## Assessment of Planning Proposal

6 Jacksons Road, and  
3, 6, 8, 10 and 12 Boondah Road

Prepared for: Pittwater Council  
Project No: 8730A  
Date: March 2014

Figure 12 Developable area as mapped in the Warriewood Strategic Review – Hyrdology Study, 2011

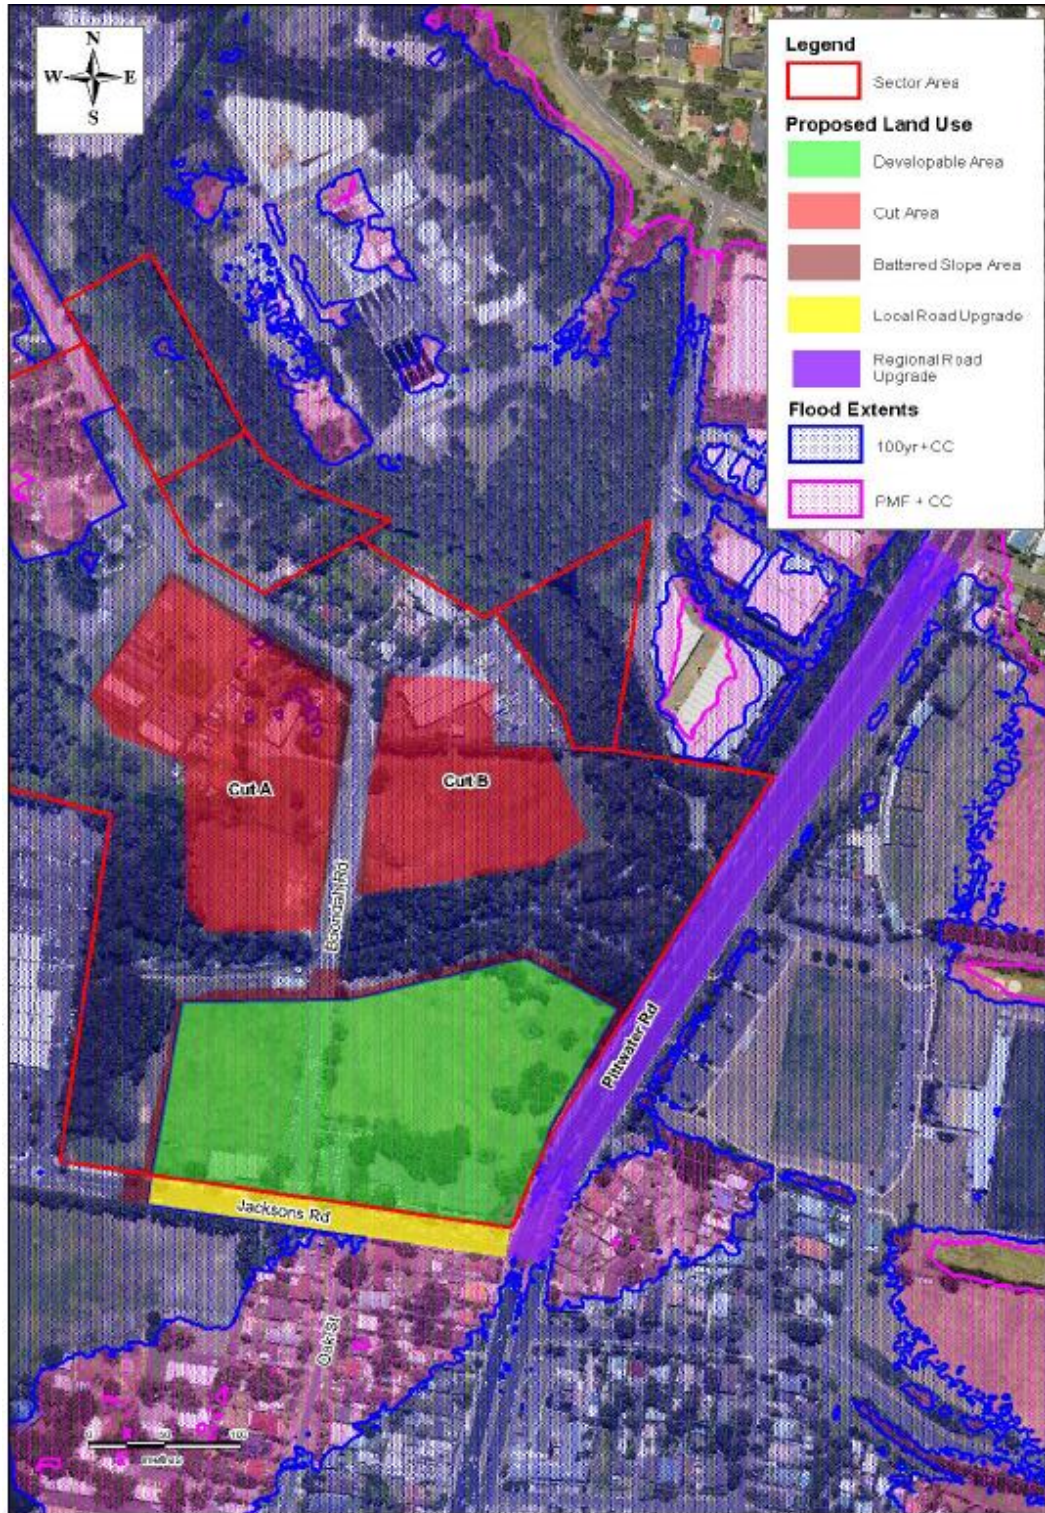
In relation to the mapped areas show in **Figure 12**, the developable area was calculated at 3.66ha. This area was selected as it has the shallowest existing flooding depths and therefore requires the least amount of fill and was found to provide the best opportunity for flood evacuation. The key recommendations in Section 11.1 of the Hydrology Study for the Southern Buffer are:

Figure 13 Potential options for the interface of the new town centre and the existing ground levels

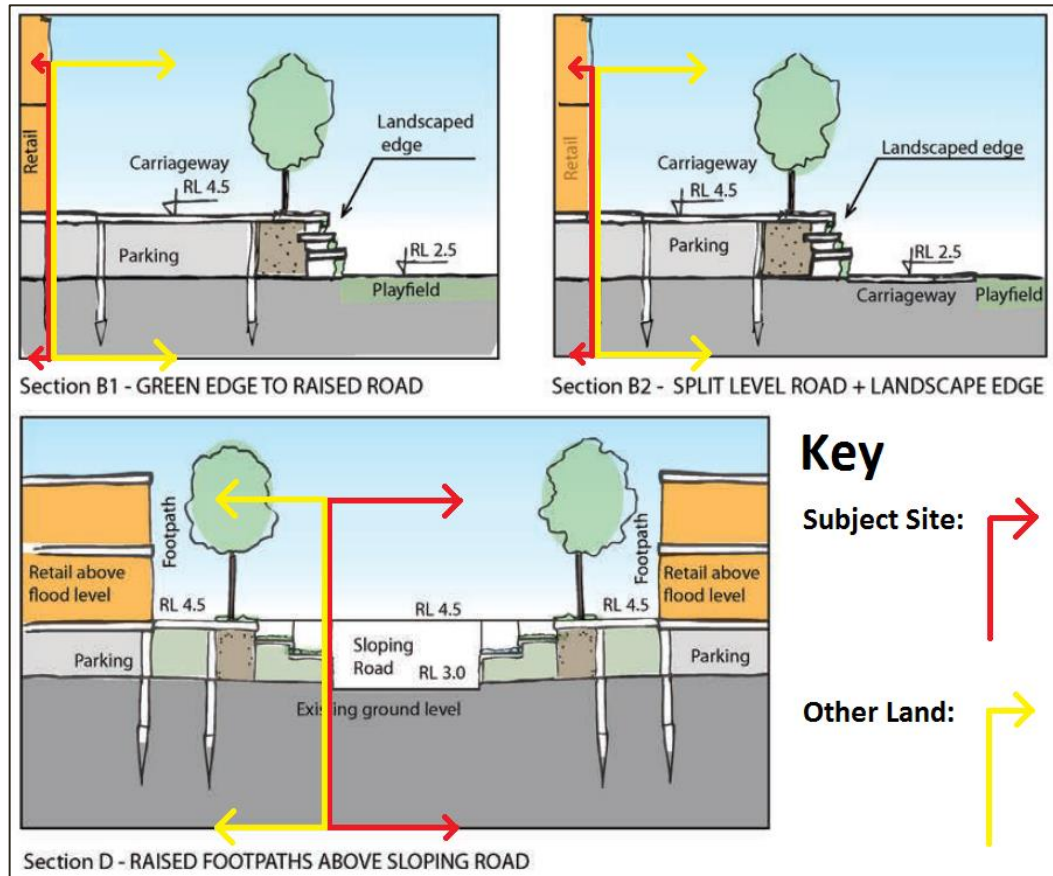
As noted in Section 9.1.2, the suspended floor approach creates elevated roads to the public domain, including roads and open space / recreation areas. The Masterplan also envisages residential development on Council and Sydney Water land that fronts Boondah Road. The Urban Design Report has suggested a potential option to address this interface, as illustrated in **Figure 13** below, which involves development over adjoining land.

The sectional illustrations are only representative, however this approach raises some urban design issues including the following:

Figure 14 Interactions Between Proposed Masterplan and Adjoining Land Owners

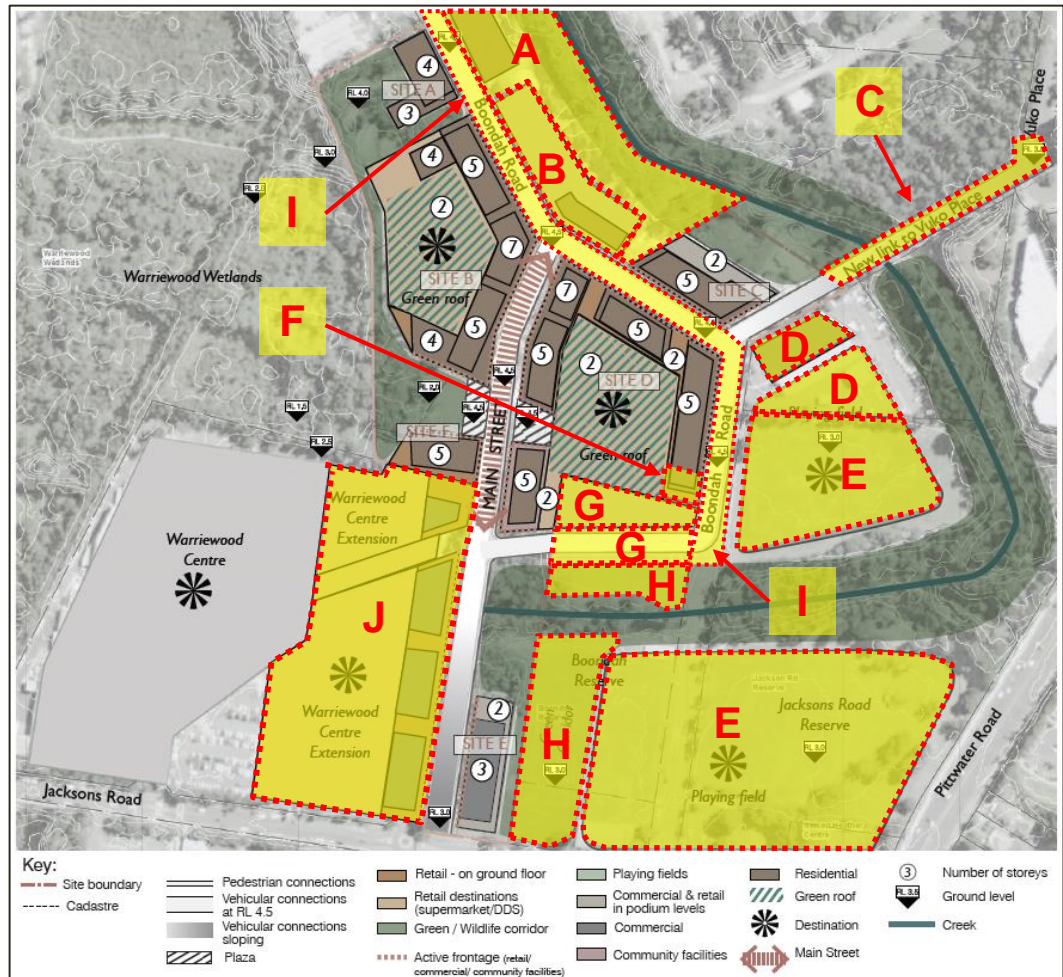
A) In response to the flood affectation of the Site, the Masterplan adopts a raised ground level of RL 4.5 for the majority of the mixed use development. This requires the raising of Boondah Road from existing ground levels, which will need to marry in with the section of Boondah Road being raised for the Meriton residential development to the north. Sydney Water has advised that it does not plan to dispose or rezone any of its land holding (including Lots 8 and 9 DP 26902) as it may be required for future upgrades of the Warriewood Sewage Treatment Plant and Depot facility. Accordingly this land risks being isolated by the raised road and/or risks having site access significantly reduced or impeded due to level differences of between 1.0 and 2.0 metres.

- I) A direct consequence of the Planning Proposal will be level differences between land adjacent to the proposed B4 zone and adjoining land (e.g. Sydney Water and Council owned land adjacent to Boondah Road). The road construction could require batters and landscape edge treatments (as illustrated in **Figure 13**) that would need to be constructed on land not within the site boundaries of the Planning Proposal.
